Reply to the attention of Sara Huber
ALC Issue: 52168
Local Government File: A2018.207-ZONE

Re: Regional District of Okanagan Similkameen Electoral Area A Official Community Plan and Zoning Amendment Bylaw Nos. 2450.14 and 2451.27

Re: Rezoning Application for 1750 Highway 3 East (PID: 002-165-481)

Re: Comments regarding file A2018.207-ZONE

Proposal Map:

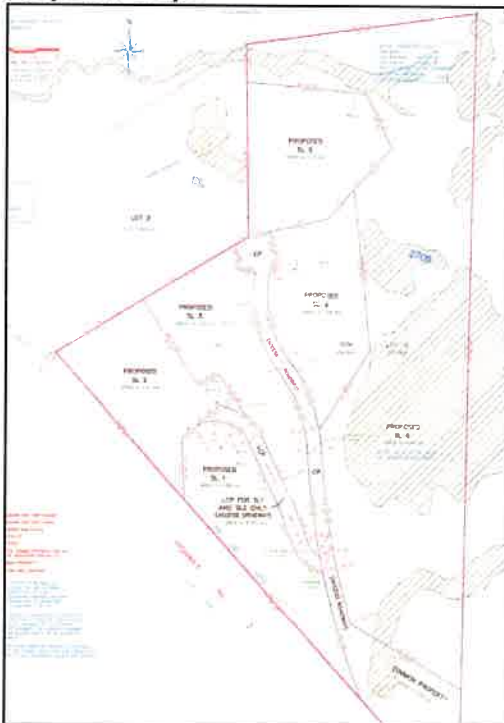
The ALC recognizes that the Property is not within the ALR and while separated by Highway 3, is adjacent to ALR lands. In particular, Strata Lot 1 and 2 are adjacent to the Highway. For this reason, ALC staff recommends considering the setback and buffer requirements outlined in the [Guide to Edge Planning](#), including up to a 30 m building setback from the ALR boundary, and an associated 7.5 m vegetated buffer to reduce the potential for urban/agricultural conflicts.
